*2025-009 ARCHITECTURAL AND
ENGINEERING SERVICES FOR THE DESIGN OF A
NEW 911 COMMUNICATIONS CENTER*

4.24.2025

Questions & Answers

Existing Site Plan

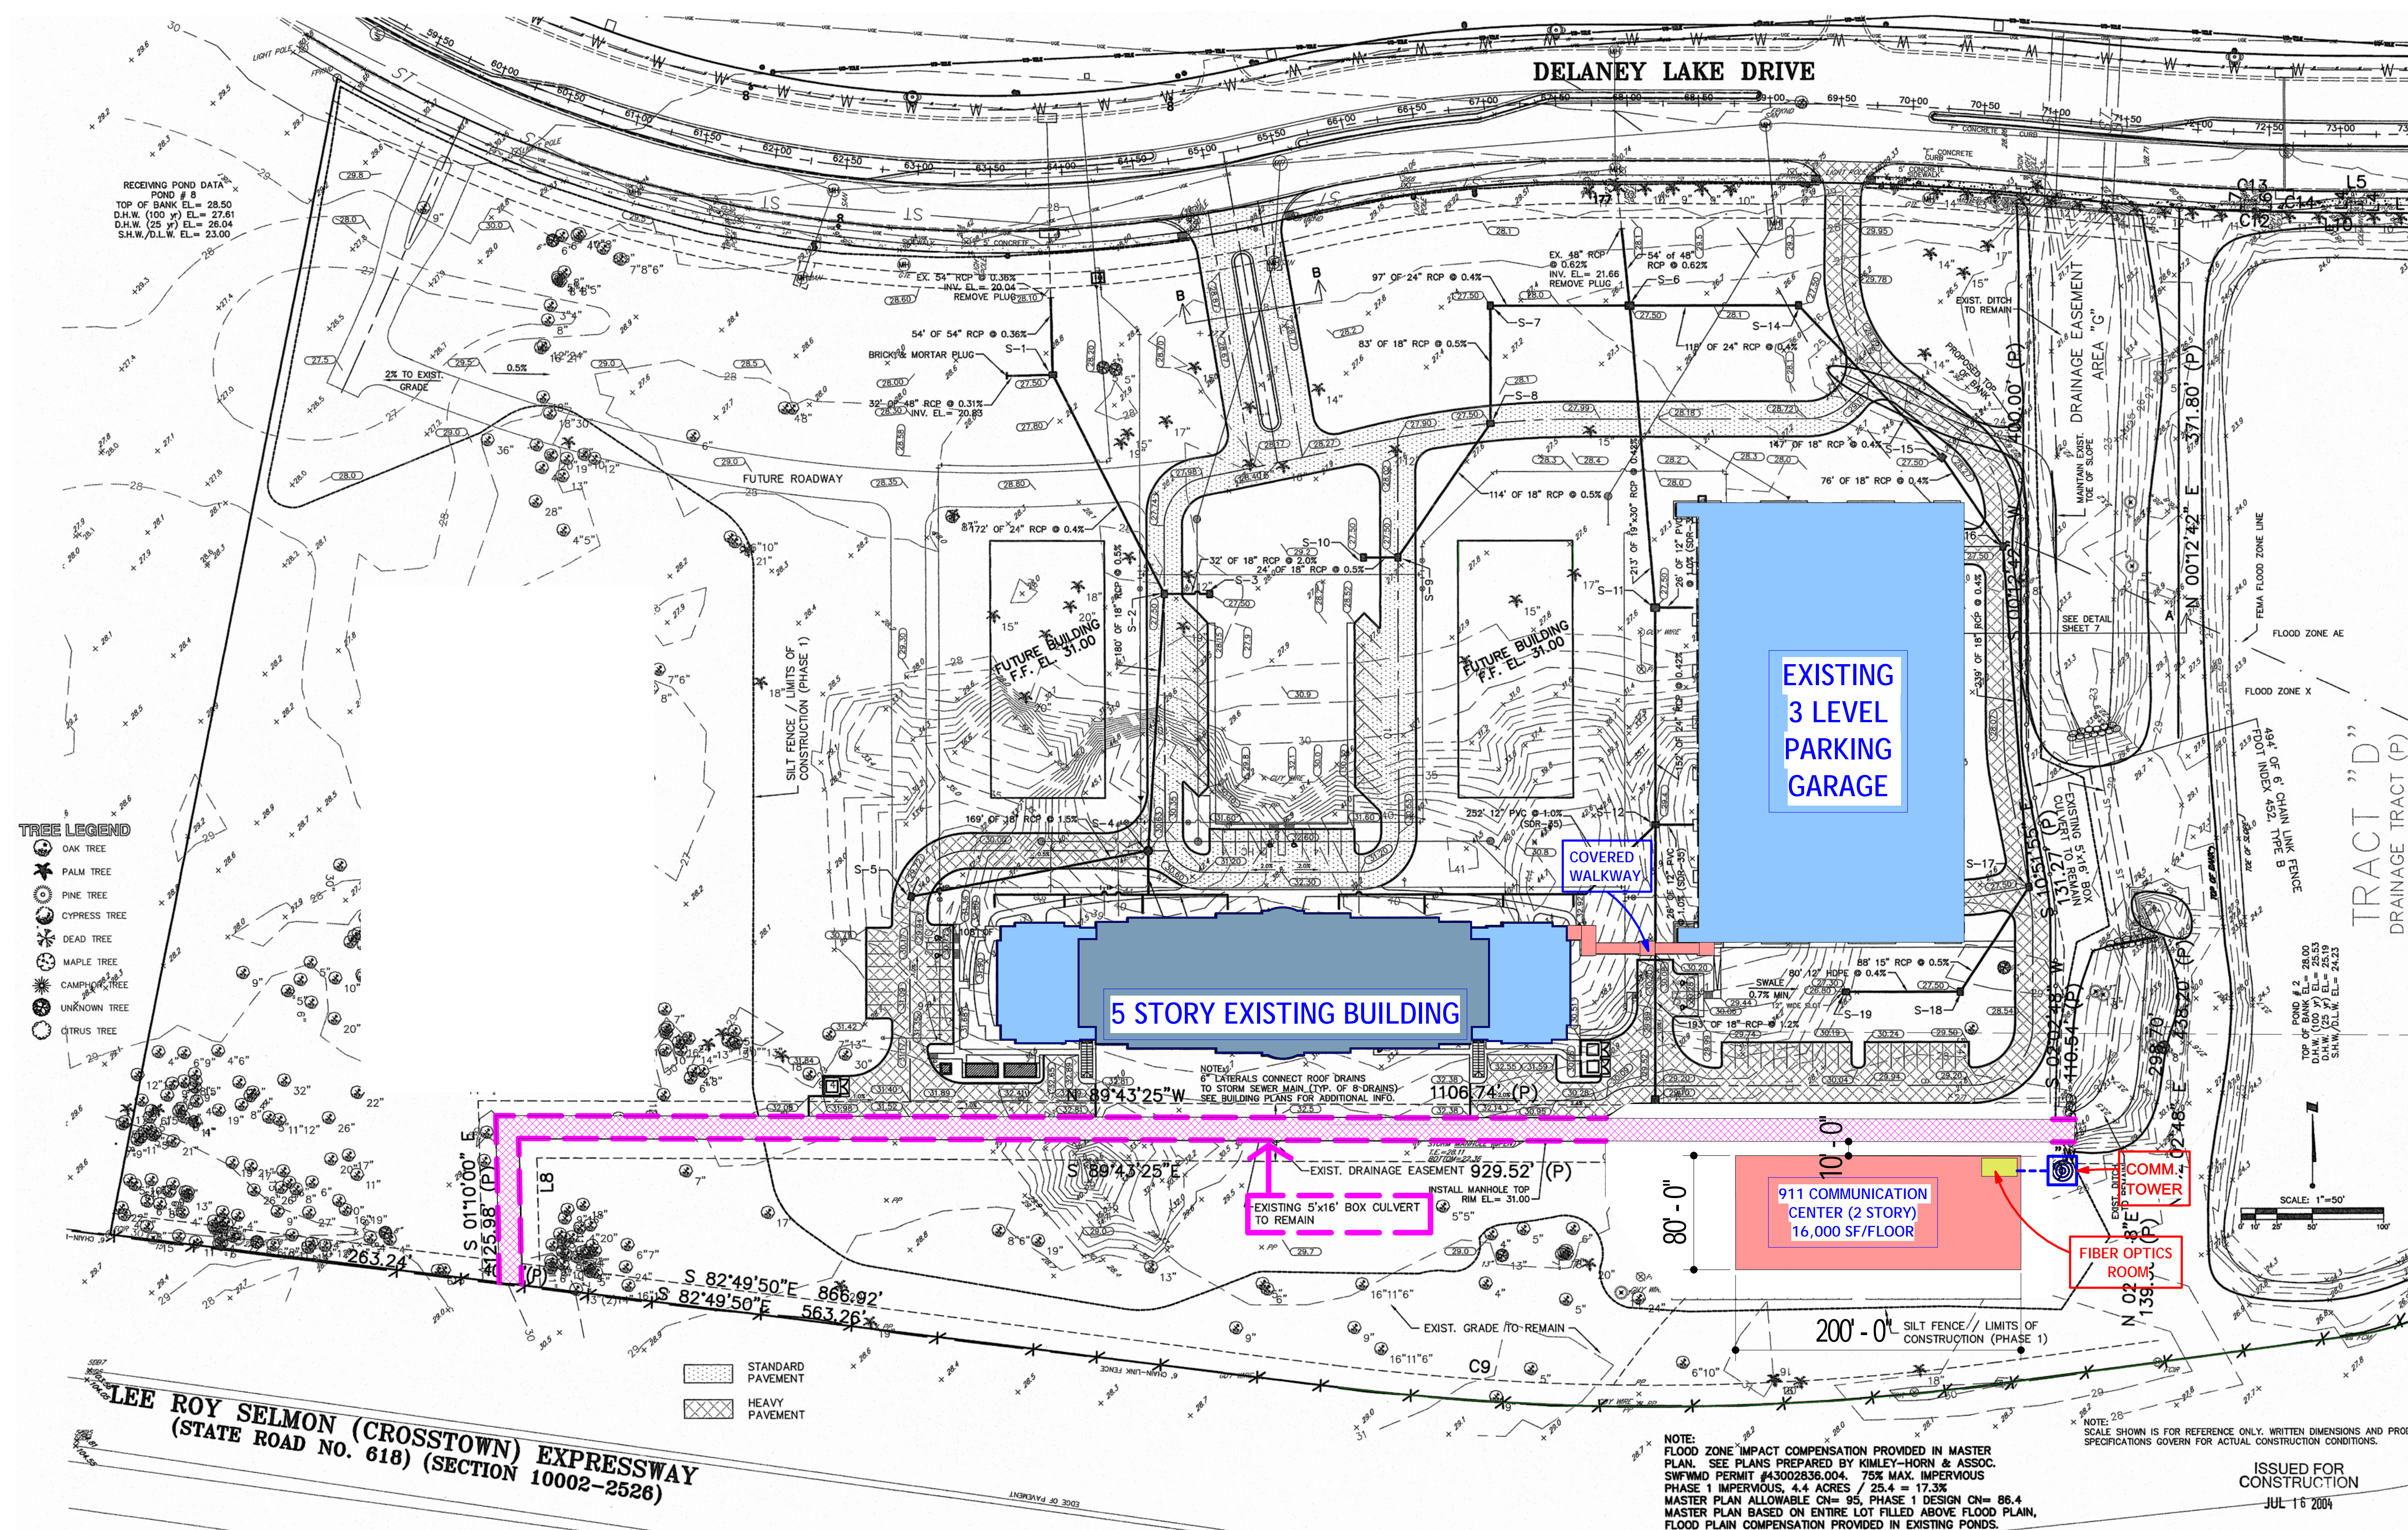
- 1. Can the HCSO please give an approximate site location on the campus?**

Answer: See Attached
